## Ligado's Technical Response to Iridium's December 14 Letter

This paper responds to Iridium's December 14 Technical Response<sup>i</sup> and its accompanying Aviation Analysis,<sup>ii</sup> which offered a criticism of Ligado's November 2 critique of Iridium's methodology<sup>iii</sup> and also for the first time raised aviation use case concerns. This submission responds to those issues in turn.

**Figure 1**

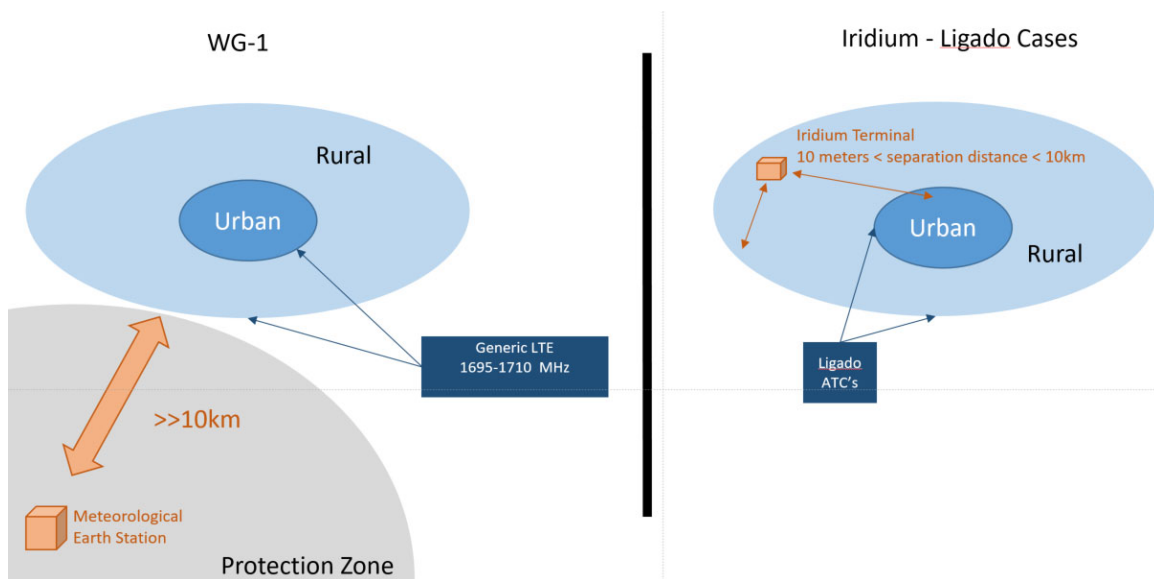
- The WG-1 scenarios and Ligado-Iridium use case scenarios are substantially different
  - As shown in Figure 1 below, WG-1 analyzes interference scenarios at long range where the receiving meteorological earth station is physically outside and distant from an operating LTE network. WG-1 chose propagation models suitable to that use case and that do not consider local clutter near the LTE devices.<sup>vi</sup> With separation distances from 1 kilometer to as large as 99 kilometers, propagation models such as the Irregular Terrain Model [ITM, also known as the Longley-Rice model]) were deemed suitable, whereas models considering devices located within building clutter and at shorter separation distances (*i.e.*, less than 20 kilometers) were dismissed by WG-1.<sup>vii</sup>

- The WG-1 scenario used the ITM model, which considers terrain variations but not clutter. Such a model is appropriate where the interference source is at a great distance from the victim (*i.e.*, source and victim are in different geographic regions) and the transmitted radio waves propagate over mostly uncluttered terrain. In the present scenario, both the Ligado and the Iridium terminals are within 10 kilometers of each other and both are in a cluttered environment. Hence, the use of the ITM model is inappropriate in Iridium's present scenarios.

- The use cases raised by Iridium involve separation distances ranging from 10 meters to 10 kilometers. The specific use cases provided by Iridium involve short range considerations where the Iridium and Ligado LTE ATC antennas may be located below rooftop height and may be in the presence of building clutter. The WI-NLOS propagation model supports modeling such use cases.

**Figure 4**

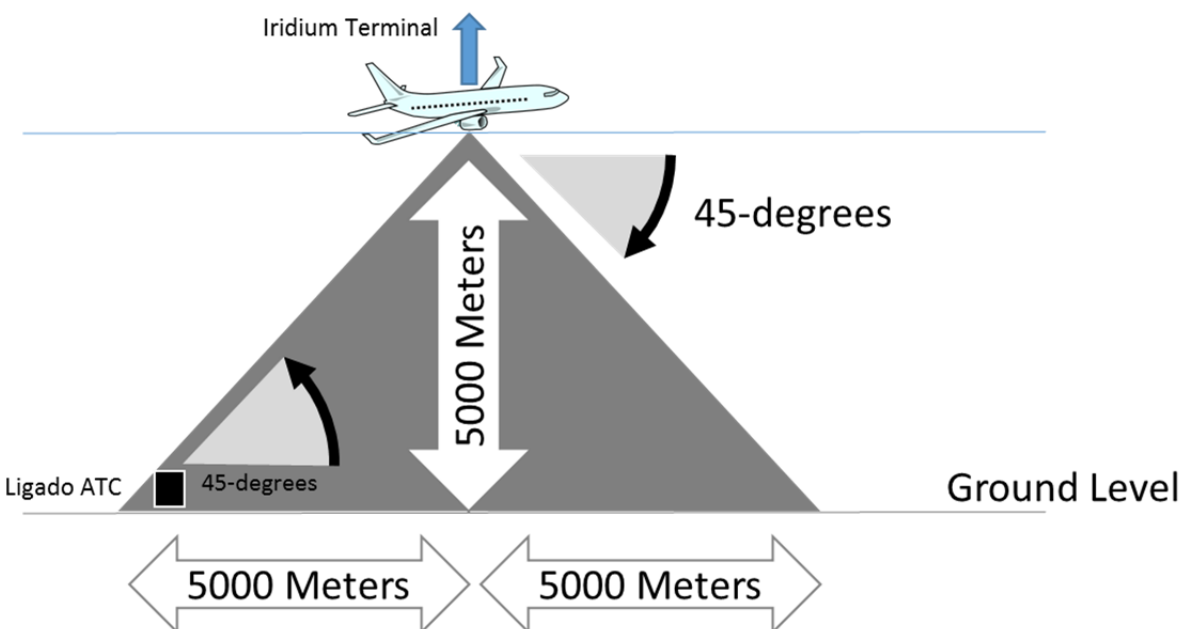
With the Iridium antenna mounted on top of the aircraft to achieve connectivity with overhead satellites, Ligado terminals nearest the airborne craft will be below and obstructed by the fuselage itself. These implementation losses due to incidence angle and fuselage blockage are not considered in Iridium's analysis and would further improve Iridium's margin. Mobile Satellite Ventures in their recent September 2 filing stated that signals originating 30-degrees below the aircraft are subject to 10 dB attenuation.<sup>xxx</sup> Moreover, ECC Report 233 found that aircraft fuselage attenuation is calculated to be 5 dB,<sup>xxxi</sup> and "for signals originating from the ground signal blockage due to the fuselage could be expected since the aircraft satellite antenna will be installed on the top of the aircraft".<sup>xxxii</sup> For the purposes of the present analysis, Ligado applies 6 dB loss due to fuselage blocking in the airborne use cases.

gain is decreasing towards the ground (i.e. below the horizon), as is typical for L-band satcom antennas. As shown in Figure 4, for aircraft at 5,000 meters altitude the Ligado devices within 5 km horizontal separation are at least 45-degrees below the horizon as shown in the figure below. Similarly, at 500 meters altitude devices within 1 kilometer separation distance are more than 26-degrees below the horizon. Utilizing a typical quadrifilar helix antenna and the example described in this section, the antenna gain at -45-degrees relative to the horizon is seen to be approximately -12 dBi. Relative to Iridium's baseline of -6 dBi antenna gain towards horizon, Ligado applies 6 dB additional isolation to signals originating in the shaded area described in Figure 4. Due to the lower geometric spreading loss and less clutter in the shaded area of Figure 4 relative to the area outside, the emitters outside the shaded area make less contribution to the aggregate weighted average path loss, in spite of the antenna gain being higher than -12 dBi. Considering contributions from all emitters, in the aggregate, Ligado applies 4 dB additional isolation (instead of 6 dB that would apply in the shaded area of the diagram) to the weighted average path loss. This 4 dB additional isolation (-10 dBi) is additive to the fuselage loss of 6 dB and the Ligado ATC antenna discrimination.

**Figure 6**

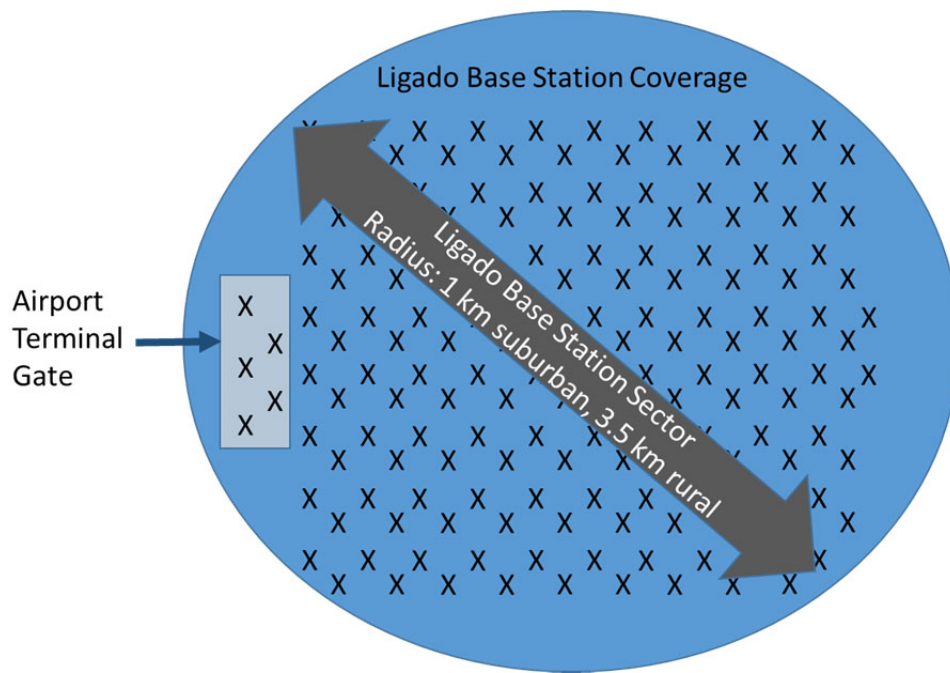
Considering the cell radius introduced by Iridium (1 km suburban / 3.5 km rural), the Ligado base station coverage in this use case encompasses a significant portion of an airport. It is reasonable to assume that the five Ligado users described in Iridium's Terminal Gate case represent a small portion of users served by the base station. These five users at the terminal gate (as depicted in Figure 6) will be interleaved via TDPS and FDPS with all users served by the LTE base station. It is unlikely, considering the service footprint of the base station and random assignment of resources to users, that the five Terminal Gate users will be instructed to transmit simultaneously (albeit at different subchannel frequencies) by the base station scheduler. Moreover, it is reasonable to assume that one or more of the five users may be transmitting at less than full power. As such, the five user aggregate case is unlikely to produce margin lower than the single user case.

**[BEGIN CONFIDENTIAL]** The resulting margin in the single and five user scenario is **[REDACTED]**

Figure 7

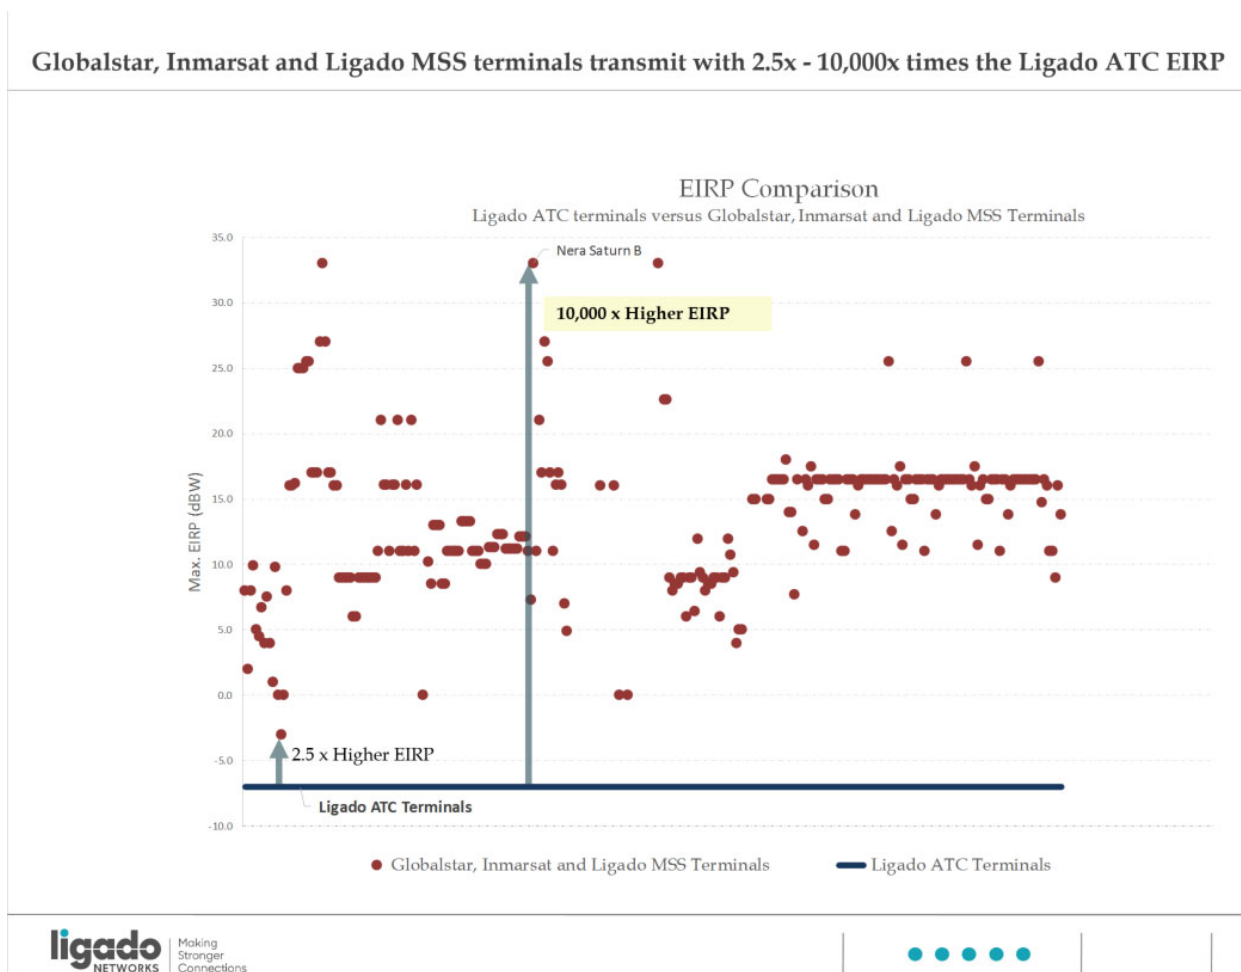
operating under the terms of their licenses such as an Orbcomm user terminal. The reason is that these other types of satellite user terminals could produce 2.5 to 10,000 times the in-band power level, and 12 to 15,000 times the out-of-band-emissions level, proposed by Ligado in its license modification applications, and in doing so, those satellite user terminals would fully comply with applicable FCC limits. See Figure 7 below.

Because the use cases involving widespread deployment of mobile earth-station terminals described above are observable every day,<sup>xxxix</sup> it seems obvious that in fact these types of high-powered authorized satellite user terminals do not disrupt Iridium service in areas around any Iridium terminal. And that leads one to further conclude that the Iridium model is unduly conservative and produces grossly inaccurate results. Instead, the Commission should examine the technical analysis presented herein that illustrates how Ligado's proposal improves the nature of the operating environment that Iridium otherwise would have to accept if Ligado's license modification is not granted and presents no realistic threat of harmful interference into Iridium.
